# SERVICE BULLETIN

M-1060

## 1997 SUPPLEMENTAL SERVICE INFORMATION BULLETIN

This bulletin provides service updates for the 1997 model motorcycles:

Figure 1. FLT Battery Cable Routing

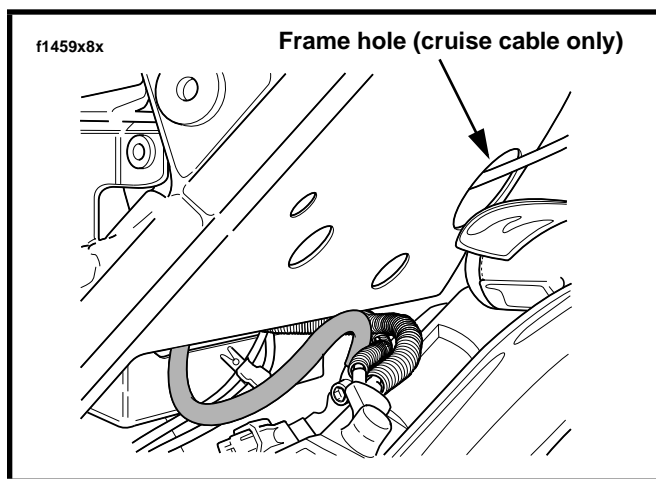
The following warning has been developed for all 1997 FLT Models to prevent damage or injury from battery cables being improperly routed through the hole in the frame cross member:

Hole on left side of frame cross member is used for cruise cable routing only. Use of the hole for battery cable routing can result in contact with hot exhaust pipe causing melting or burning of the cable insulation, damage that can lead to driveability problems or fire hazard, possibly resulting in personal injury and/or property damage.

Route all battery cables through opening between tray of battery box and bottom of frame cross member, as shown in Figure 1 below.

Figure 2. Sportster Positive Battery Cable Routing

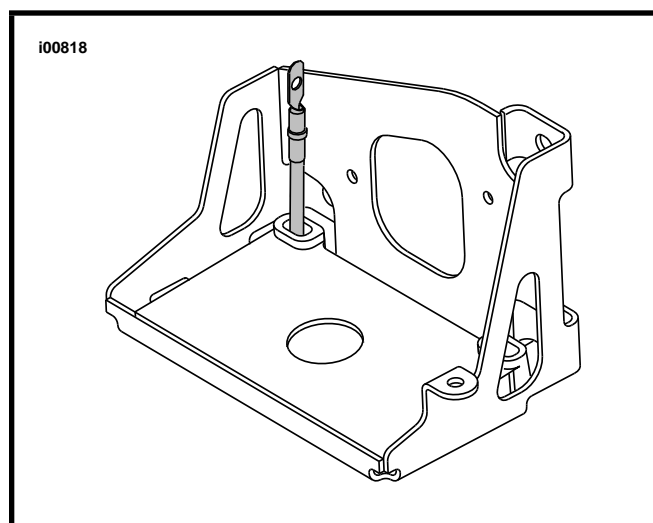
The positive battery cable on Sportsters is shipped loose outside the battery box **and must be routed up through the hole in the rubber tray liner before being connected to the battery.** Do not route cable around the outside of the battery box, or through the opening in the side of the battery box.
